State of New Mexico
 Energy, Minerals and Natural Resources

WELL API NO. 30-025-29999
5. Indicate Type of Lease STATE FEE X
6. State Oil & Gas Lease No.
7. Lease Name or Unit Agreement Name Wright
8. Well Number 002
9. OGRID Number 1092
10. Pool name or Wildcat Humble City; Wolfcamp
11. Elevation (Show whether DR, RKB, RT, GR, etc.) 3723 GR

SUNDRY NOTICES AND REPORTS ON WELLS
 (DO NOT USE THIS FORM FOR PROPOSALS TO DRILL OR TO DEEPEN OR PLUG BACK TO A DIFFERENT RESERVOIR. USE "APPLICATION FOR PERMIT" (FORM C-101) FOR SUCH PROPOSALS.)

2. Name of Operator
Armstrong Energy Corporation

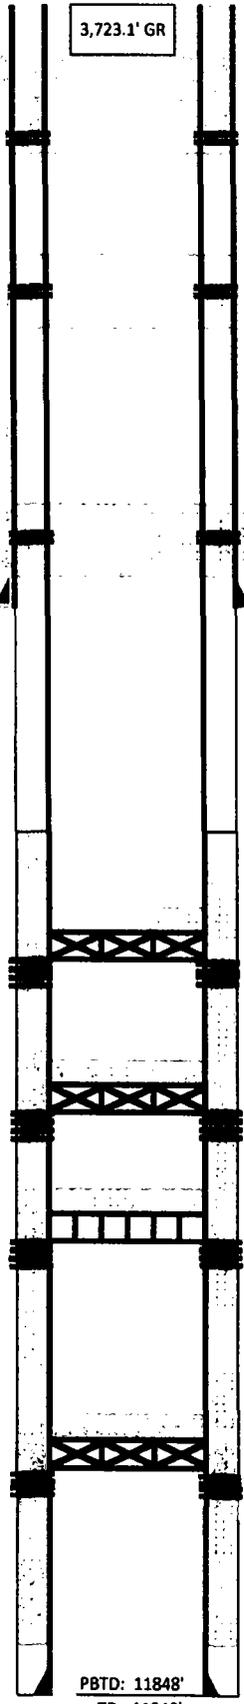
1. Set CIBP @ 9825' 35' cement on top. C;FC MCF
2. Perf & sqz 55 sx of "C" over top of San Andres/8 5/8 Casing Shoe from 4200'-4500'. P+S 55SXCLC 6800
3. Perf & sqz 55 sx of "C" over top of Salt 1900'-2100'.
4. Perf & sqz 100 sx of "C" from 480' to surface
5. Install DH Marker

4" dia 4' Above Ground M.K.R

See Attached
 Conditions of Approval

- 7) Mud laden fluids must be placed between all cement plugs mixed at 25 sacks of salt gel per 100 barrels of brine.
- 8) All cement plugs will be 100' or 25 sacks cement, whichever is greater. Class 'C' cement will be used above 7500' and Class 'H' below 7500'. Plugs should be no more than 3000' apart
